Pico Branch Library SP 2119
Addendum Number 3
RFP Document

March 6, 2012

Additional Information/ RFI Response

1.1 REVISIONS TO DRAWINGS

SHEET NO.
A4.20

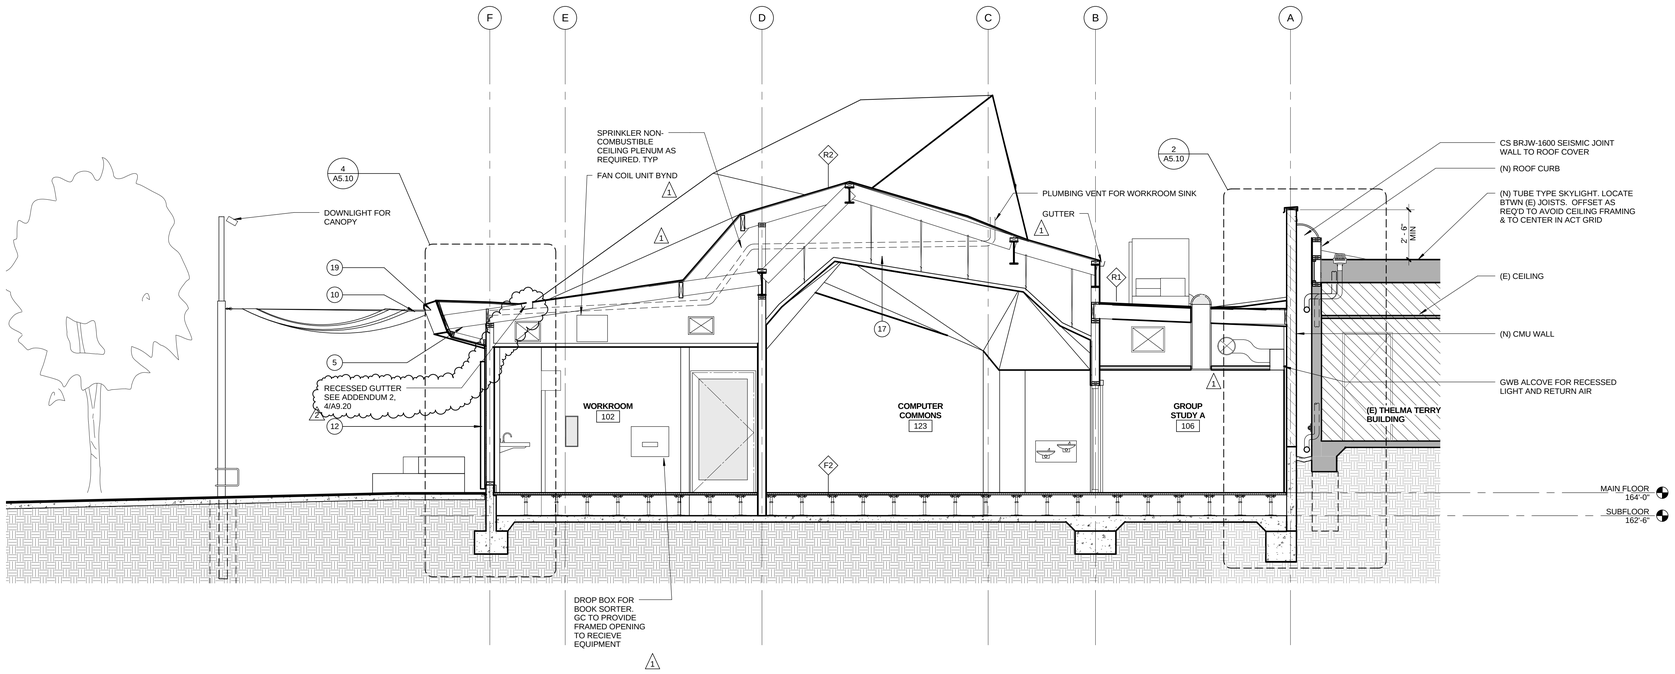
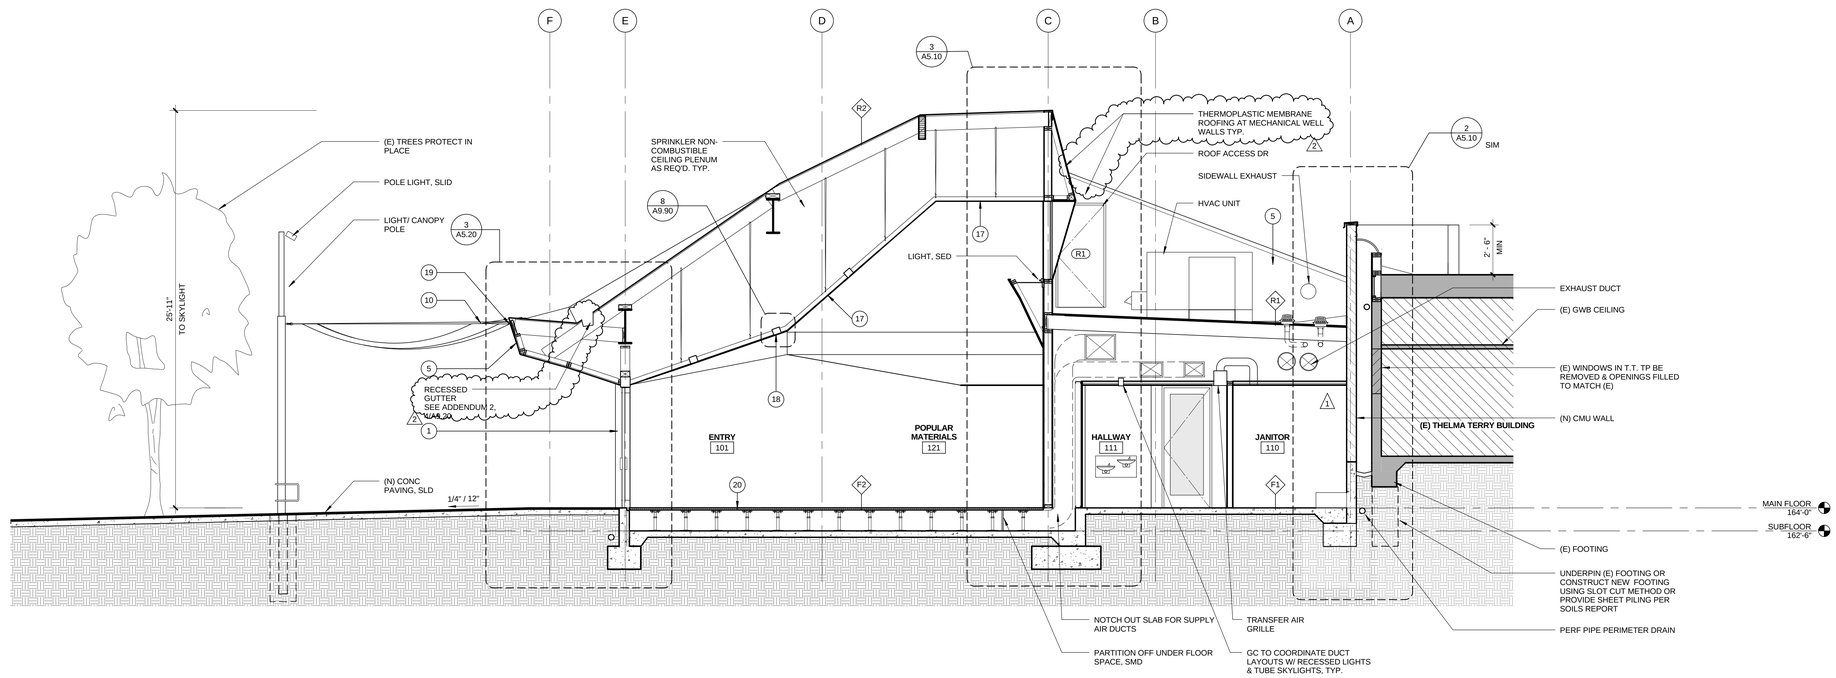
RFI#58: Library roof plan shows recessed gutter. In bldg sections these are not shown. Provide details.
ANSWER: See Addendum 2 drawing 4/A9.20 for gutter detail. See Addendum 3 revised building sections that show recessed gutter locations.

RFI#64: Provide wall IDs the rest of interior walls and walls above Library flat roof.
ANSWER: Interior walls are wall type A unless otherwise noted. See Addendum 3 building sections and sheet A9.30 for clarification on wall type above library flat roof.

SHEET NO.
A8.10

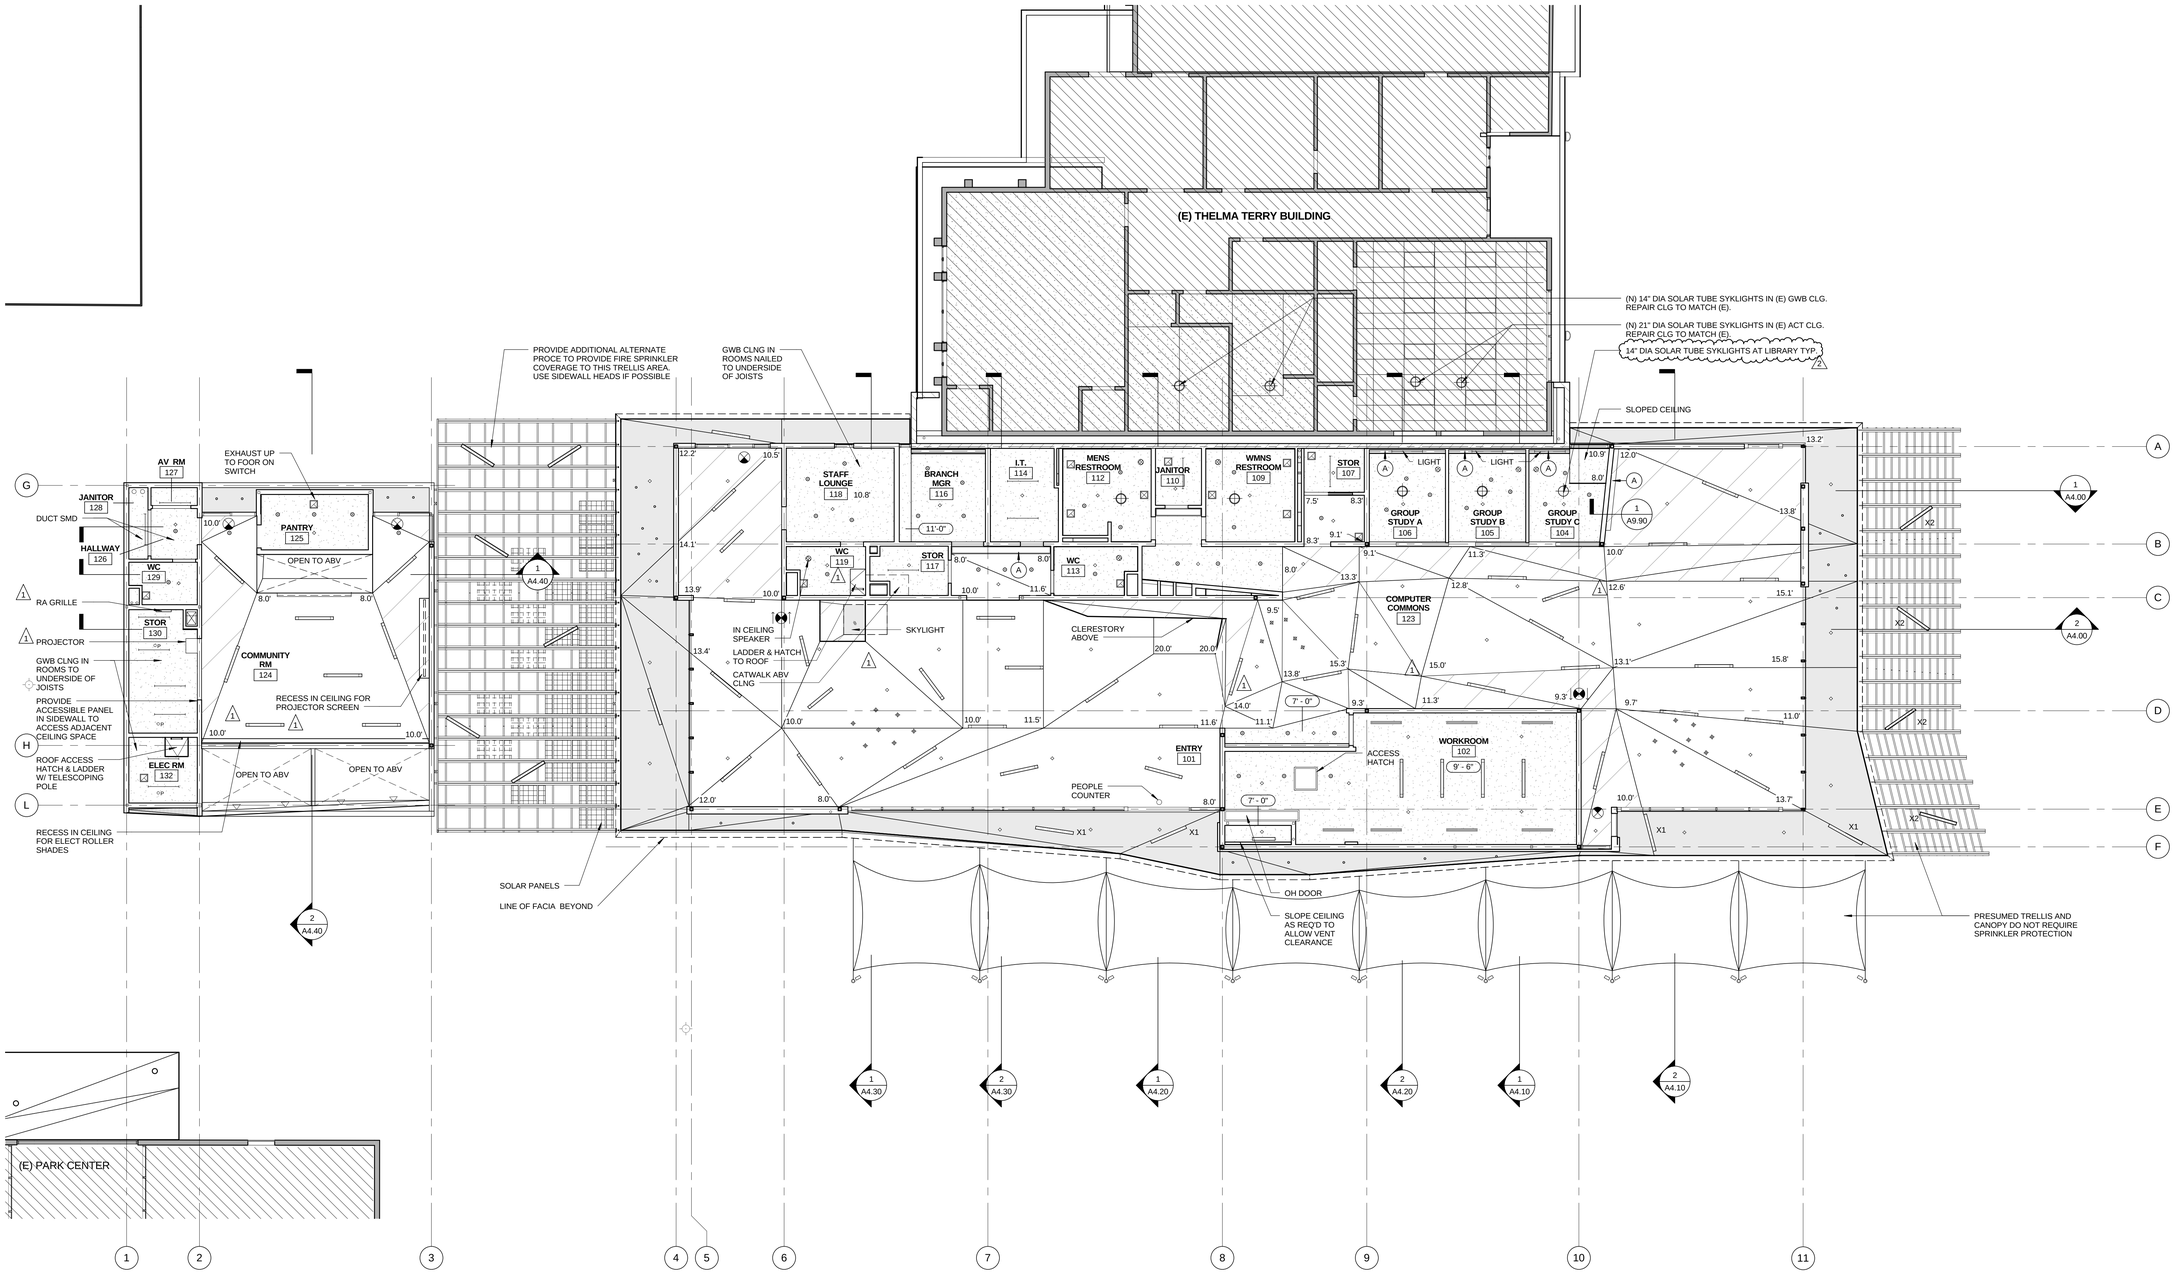
RFI#61: Provide solatube sizes in the library.
ANSWER: See Addendum 3 sheet A8.10 for clarification.

RFI#62: Soffit at Library bldg. In RCP calls for gypboard soffit while on details it is cement plaster. Please correct.
ANSWER: See Addendum 3 sheet A8.10 for clarification.

1. ALL CEILINGS 8'-0" UNO TYP.
2. SOLARTUBE SKYLIGHTS (4) TO BE ADDED TO (E) T.T BUILDING. LOCATE BETWEEN (E) ROOF JOISTS (32" OC). LOCATE SO SKYLIGHTS ARE CENTERED ON EXISTING T.T CLASSROOM ACT GRID & AVOID (E) LIGHTS.
3. LOCATE (N) LIGHTS IN RESTROOMS TO AVOID (E) LIGHTS & SOFFIT AREA OF CLG (E) CLG IS GWB @ T.T.

EXTERIOR STUCCO WALL G

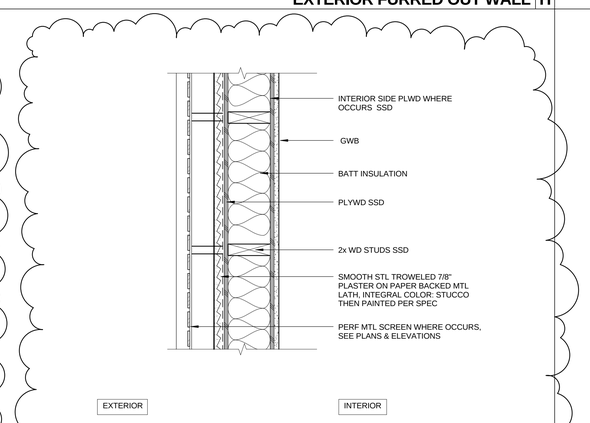
RFI#60: Metal Panels on wall type G is dimpled. In elevation, it is perforated MP. Please correct.
ANSWER: See Addendum 3 corrections to sheet A9.30 for wall type clarification.

RFI#69: On sheet A2.10 Floor Plan, All exterior wall type G's except at workroom have an exterior finish of cement plaster per elevations. Please correct.
ANSWER: See Addendum 3 corrections to sheet A9.30 for wall type clarification.

EXTERIOR MTL PANEL WALL F

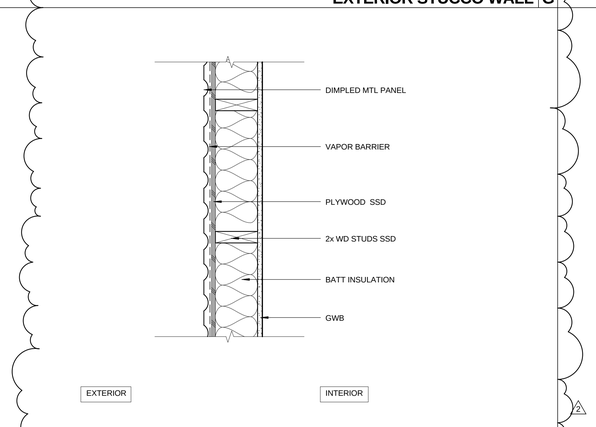
RFI#59: Metal Panels on wall type F is perforated. In elevation, it is dimpled MP. Please correct.
ANSWER: See Addendum 3 corrections to sheet A9.30 for wall type clarification.
